ADDENDUM NO. 01

September 23, 2026

**WARREN COUNTY CAREER CENTER
MEDICAL ACADEMY ADDITION
3525 NORTH STATE ROUTE 48
LEBANON, OHIO 45036**

LPA PROJECT NO. 263306.00

N.T.S. C100

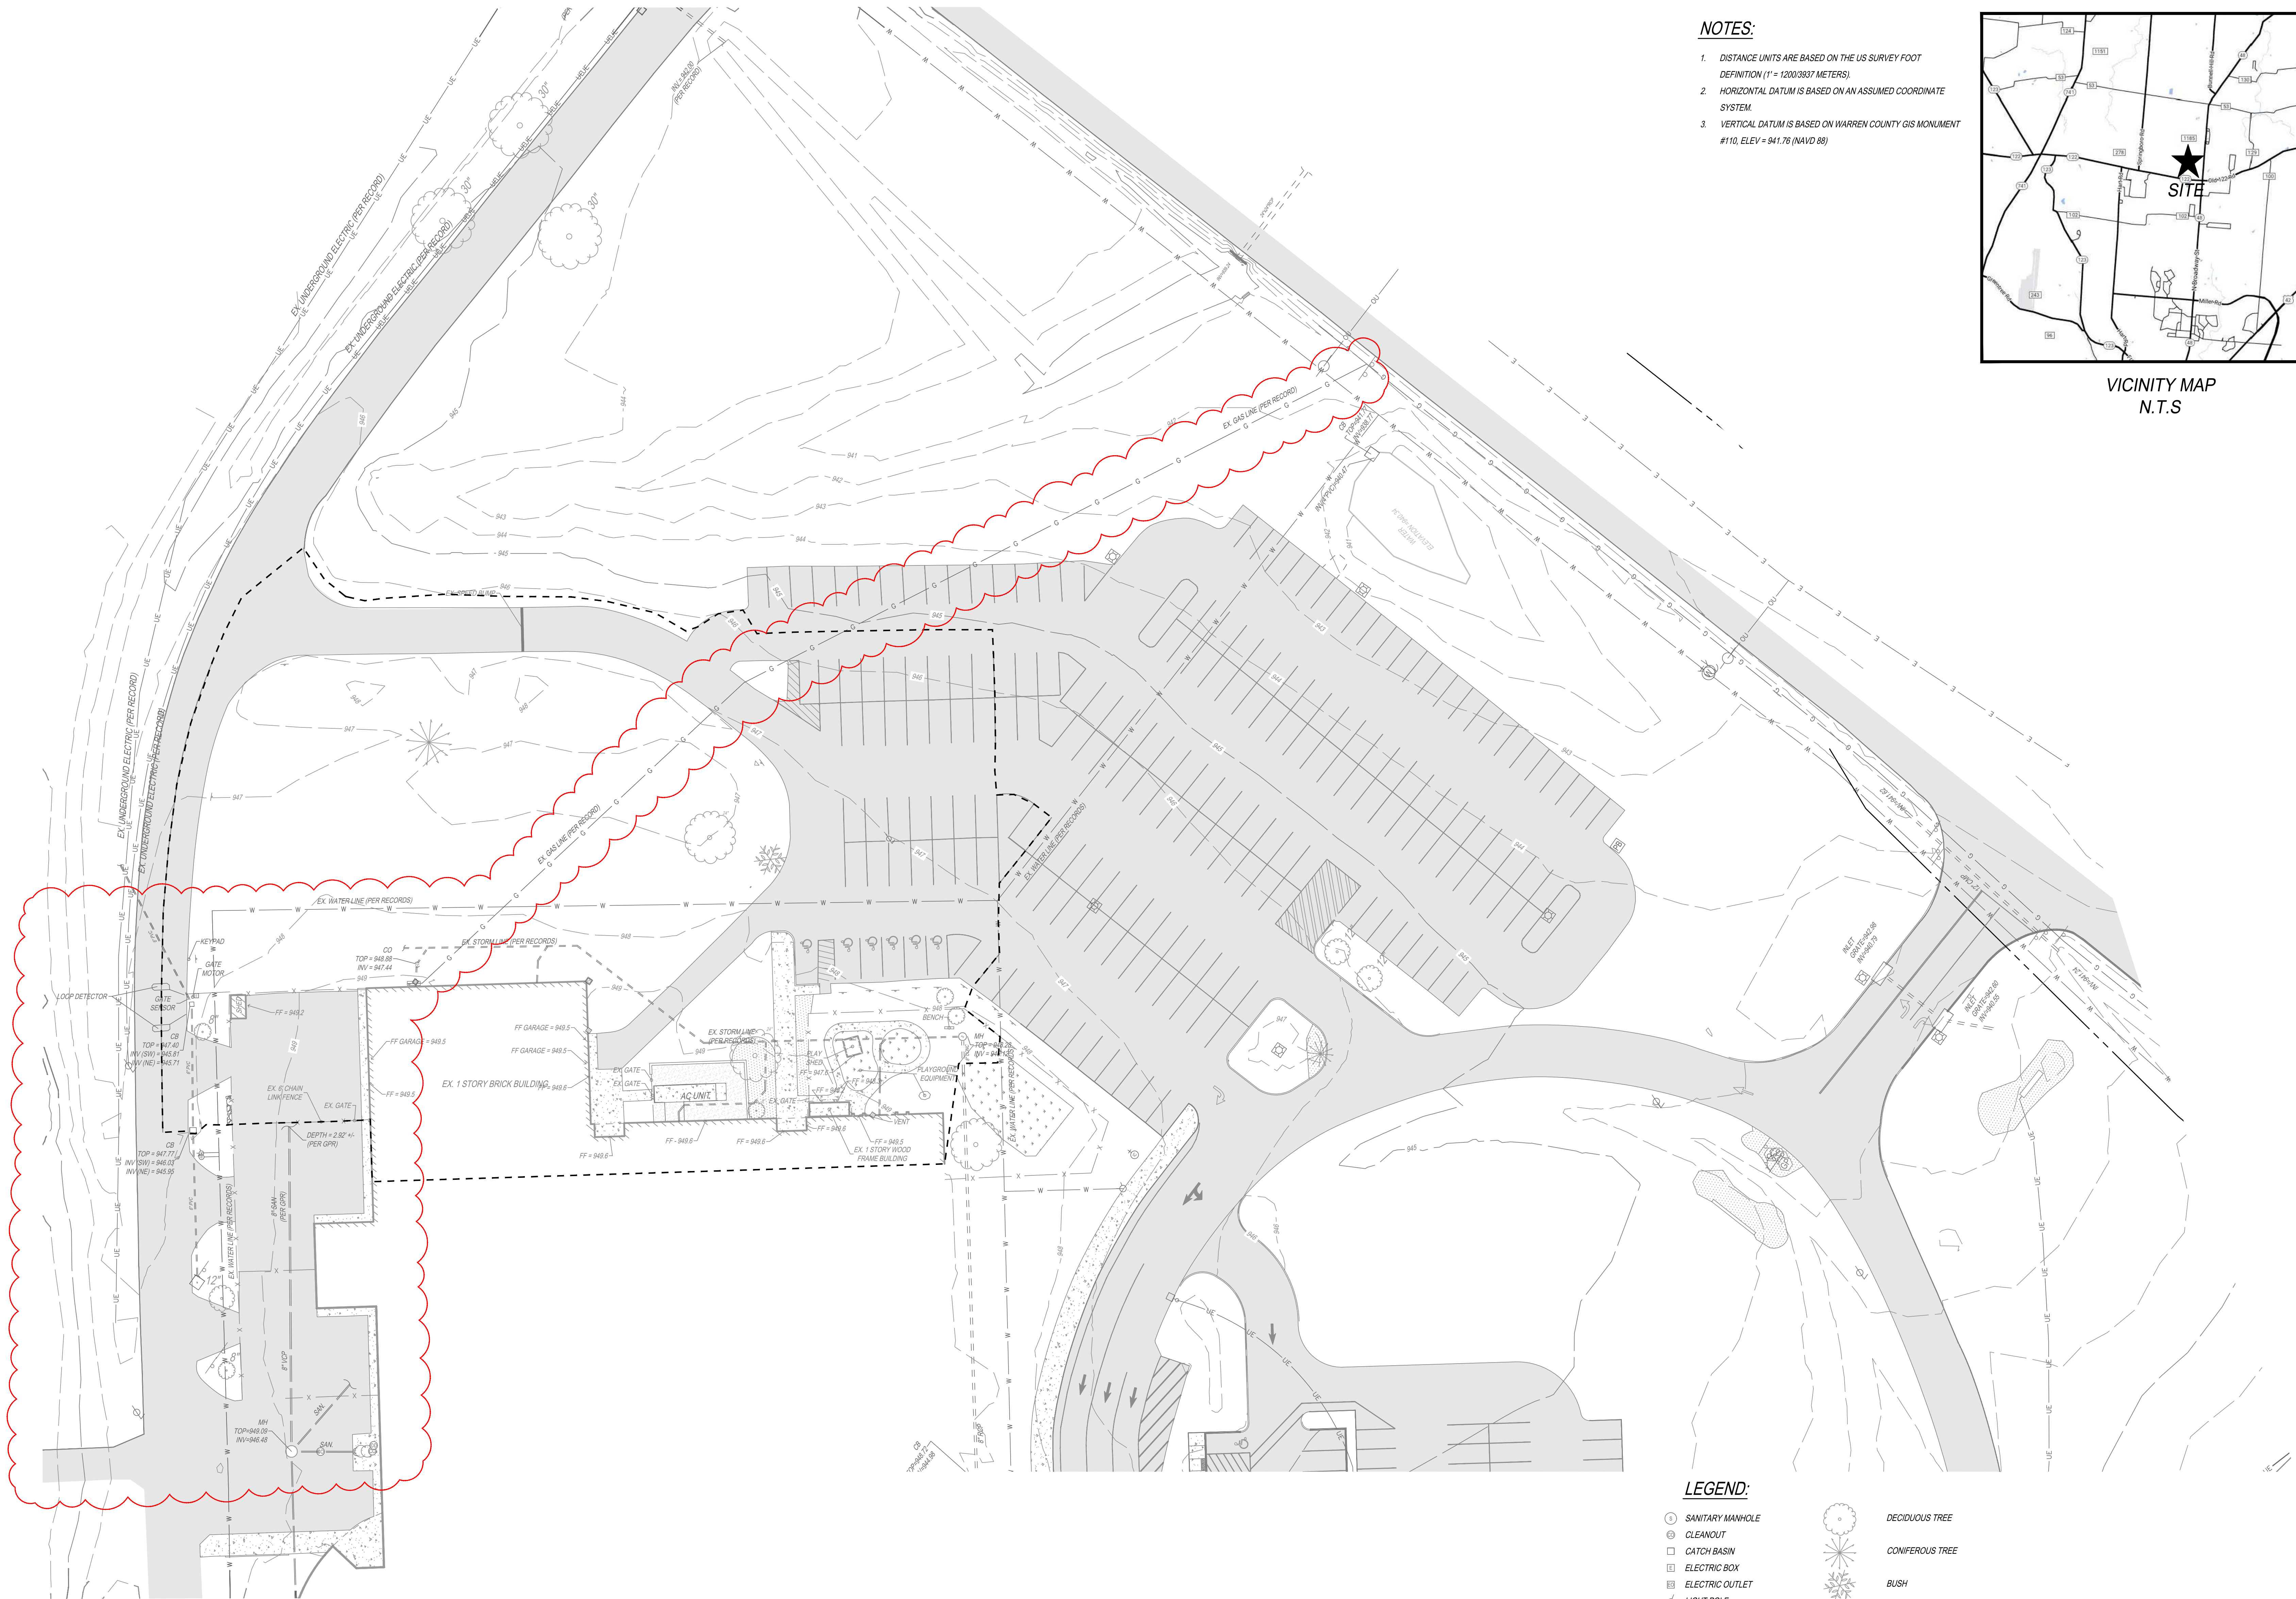
- 2.27 Sheet C100
 - Updated exterior railing type
- 2.28 Sheet C111
 - Showed existing gas and sanitary lines per private utility locate
- 2.29 Sheet C120
 - Revised extents of gas and water line demolition.
 - Removed asphalt necessary for sanitary force main installation.
- 2.30 Sheet C130
 - Updated playground to match current LA plans including fencing, curbing, and ground cover
 - Replaced asphalt necessary for sanitary force main installation
- 2.31 Sheet C140
 - Revised extents/routing of proposed gas and water lines.
 - Installed new manhole just north of addition to help with sanitary / storm intersection
 - Revised underdrain route per new playground.
- 2.32 Sheet C141
 - Added utility crossings to profiles.
 - Revised storm lines to avoid conflict with proposed sanitary pipe
- 2.33 Sheet C150
 - Revised grading to match new playground

G004

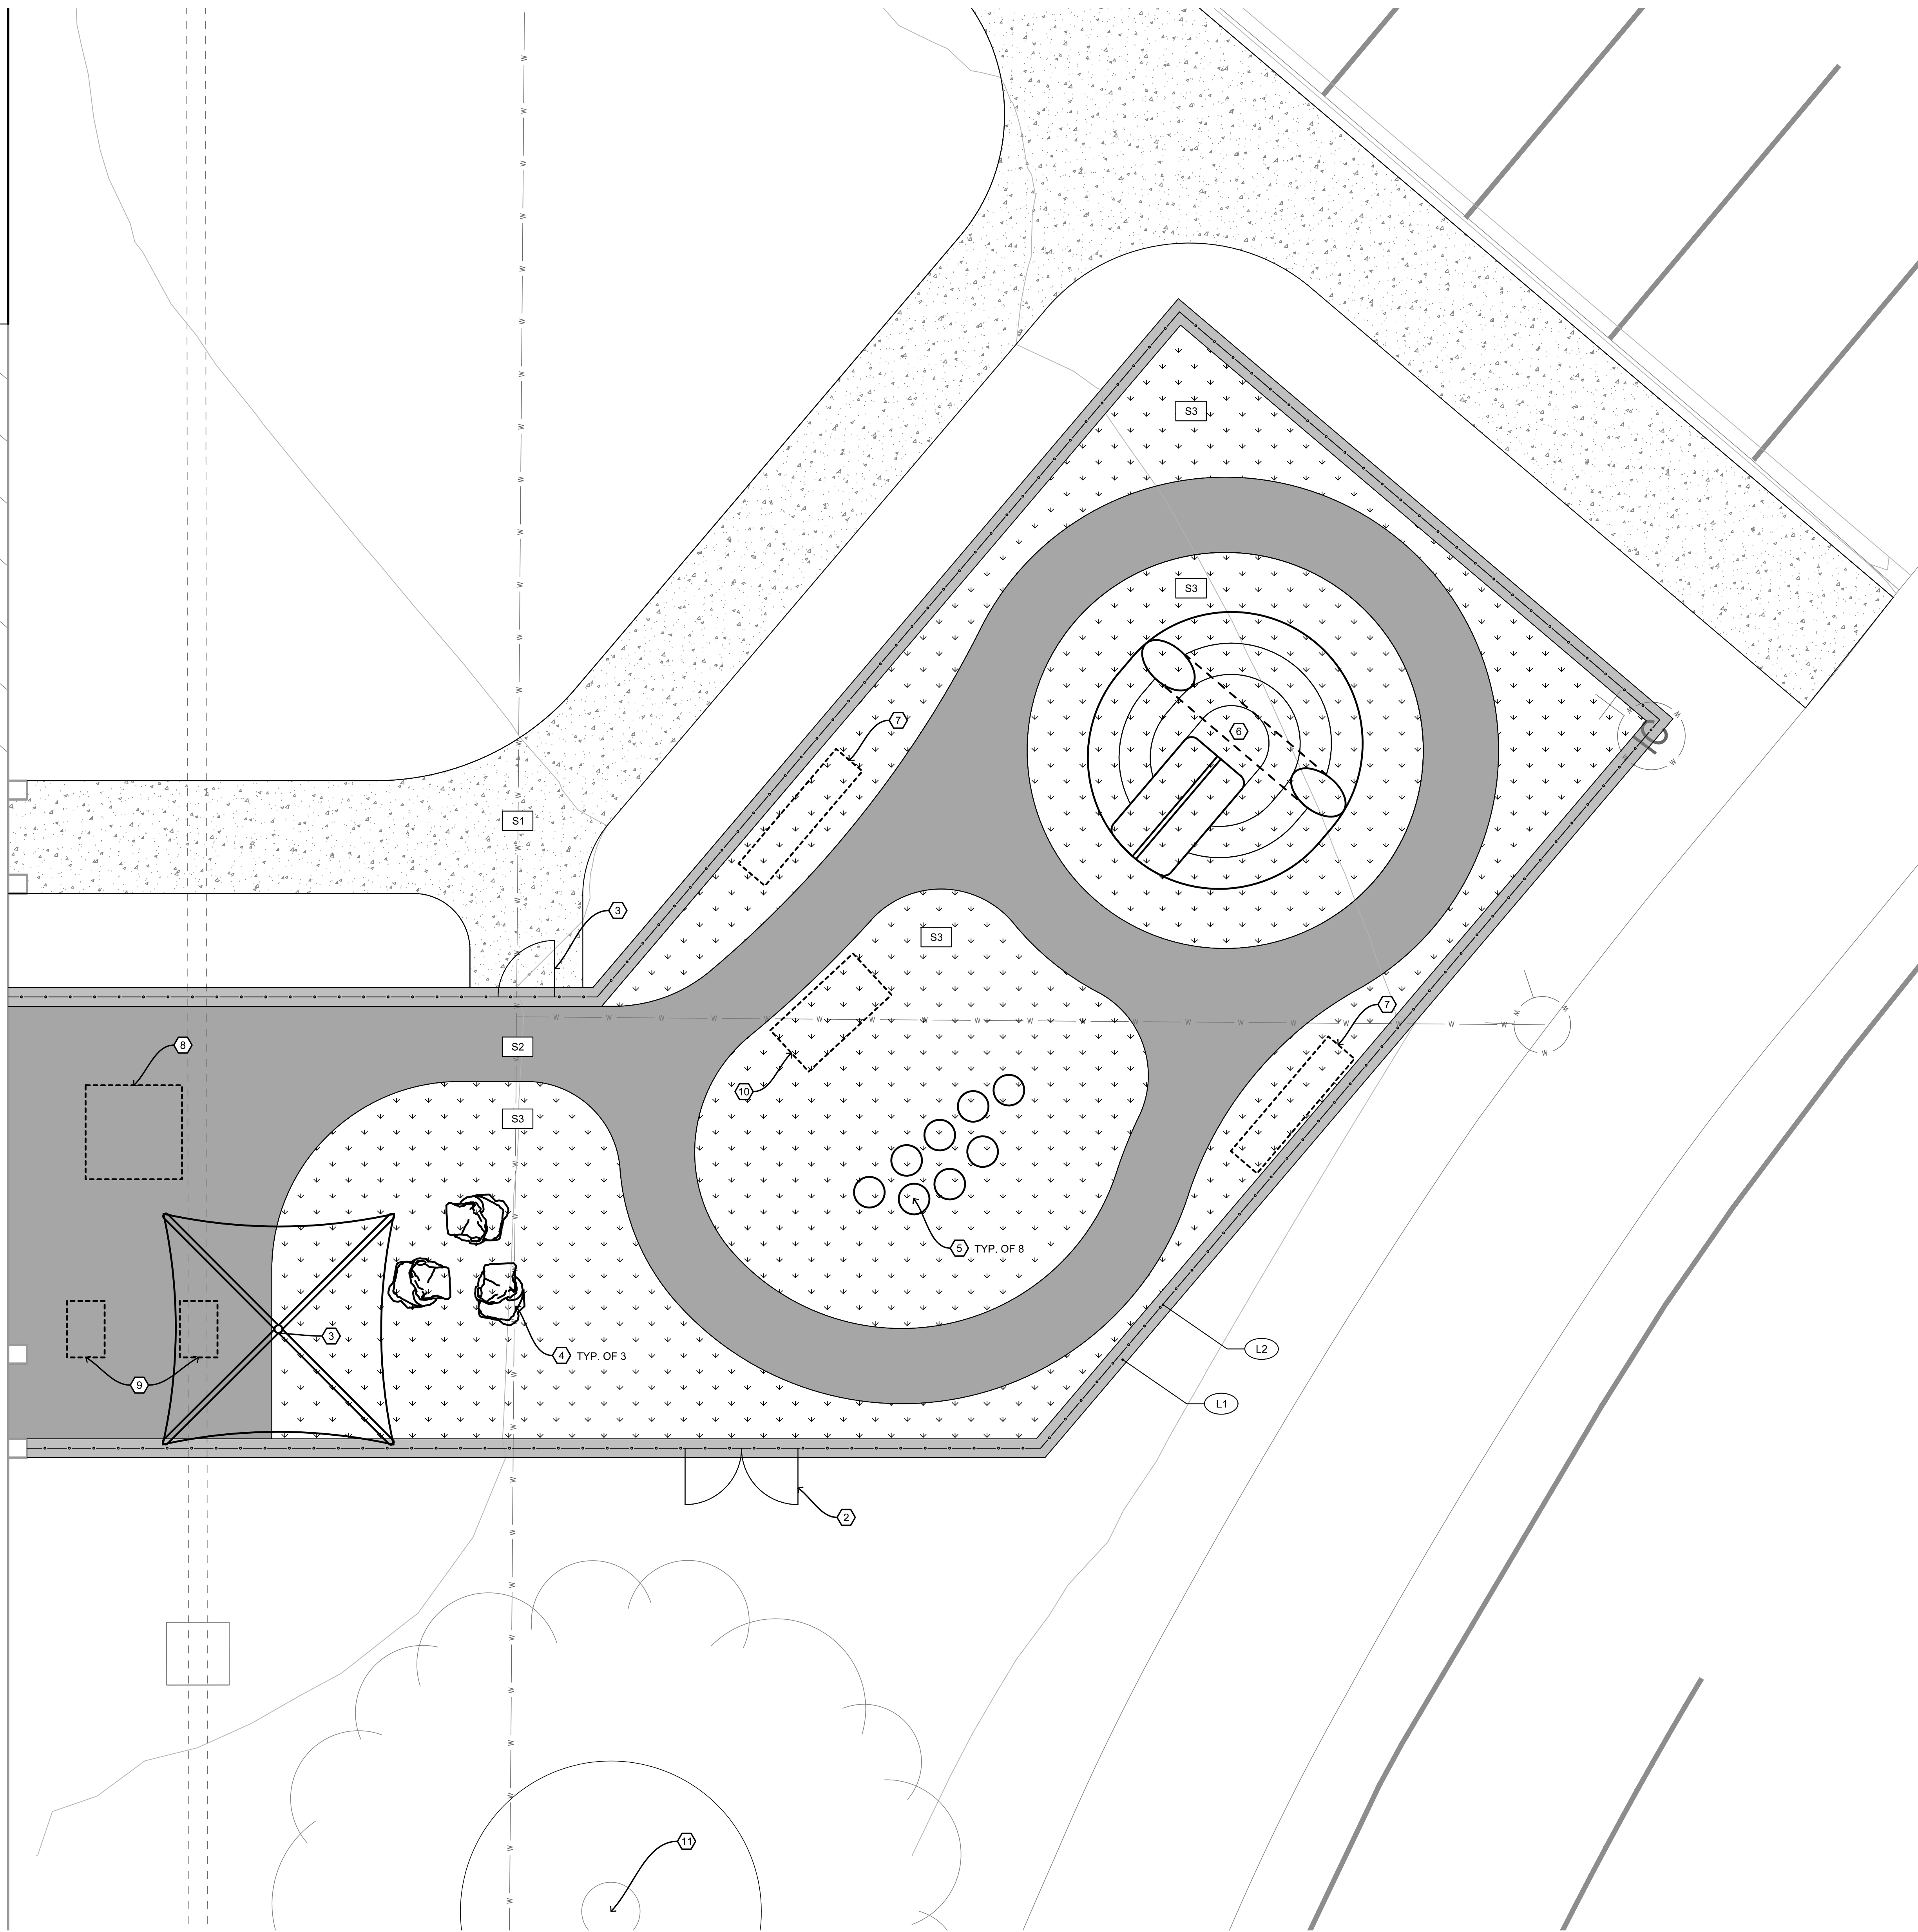
- 2.24 Sheet G004 Life Safety Plan
- Updated egress note regarding temporary barriers during construction.
- 2.25 Sheet L100 – Playground Plan
- Sheet Added to the Project

S004

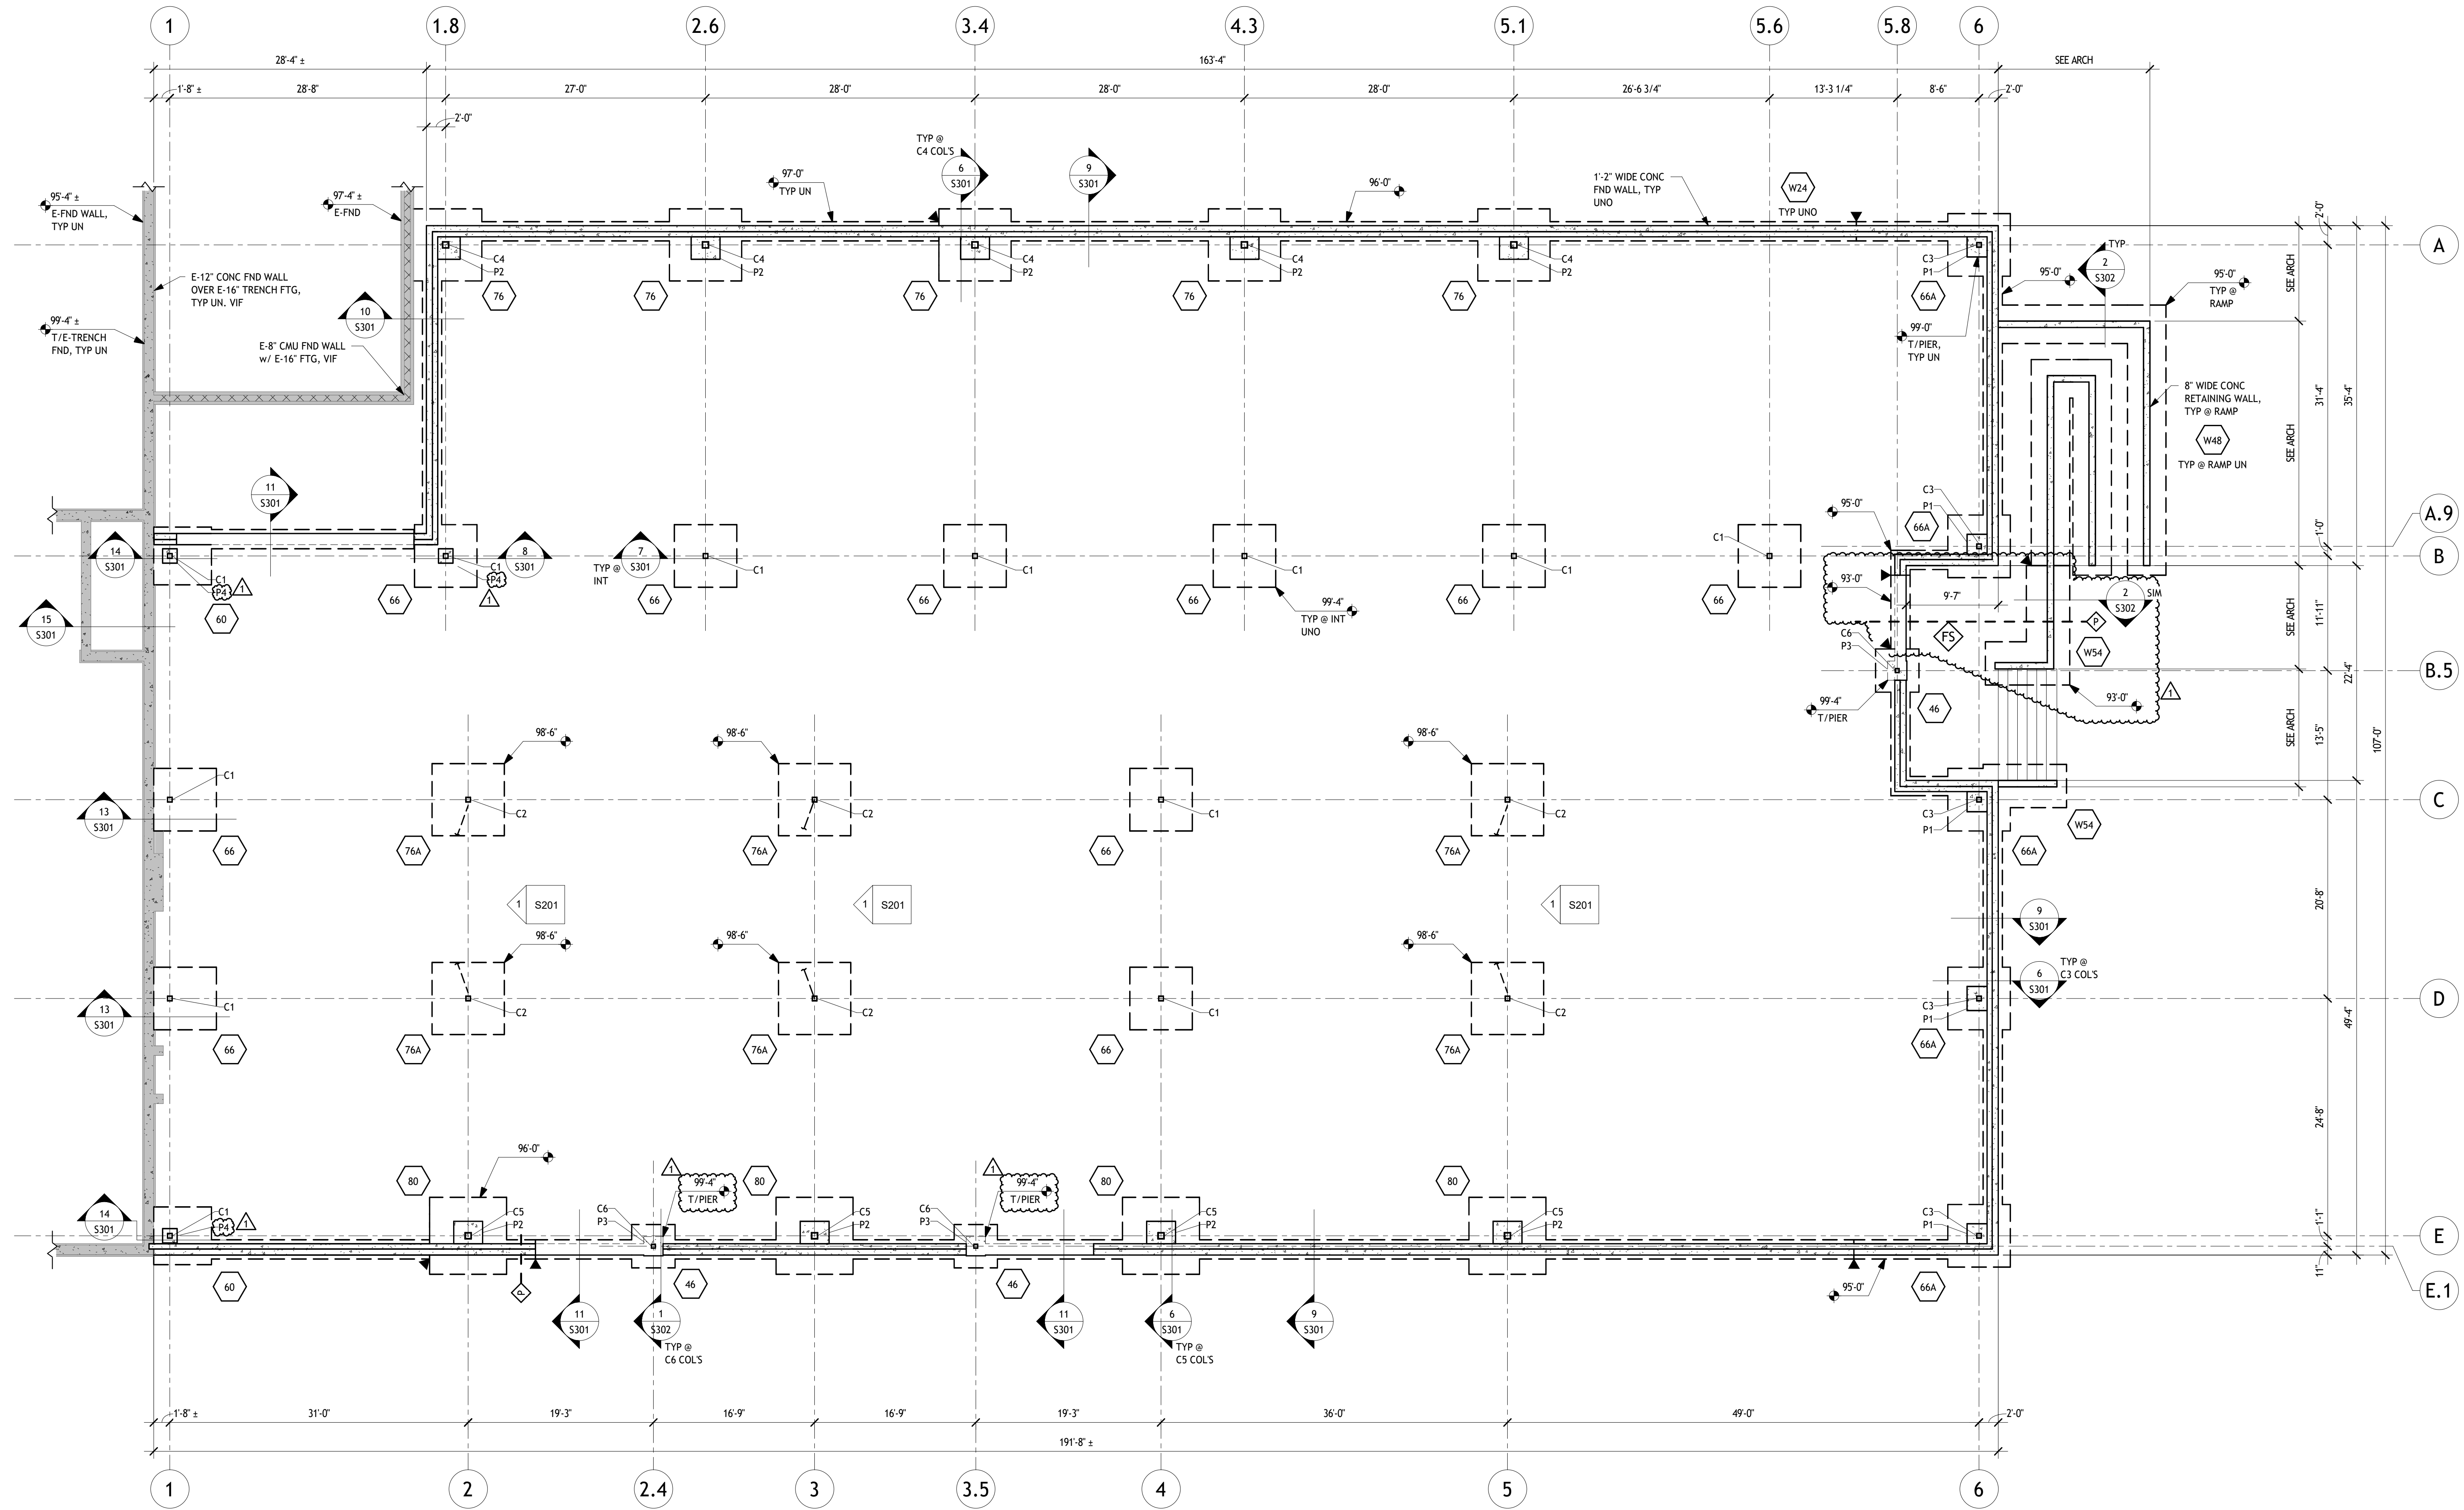
2.8 Sheet S004

- Updated anchor bolt edge distances in “Column Base Plate Types”.
- Updated columns C4 and C5 base plate size.
- Added additional remarks to column schedule.
- Added pier “P4” and updated pier reinforcing in Pier Schedule.
- Updated footing depths for footing type 76 and 80.
- Added wall footing type W54.
- Updated Pier Type Detail.
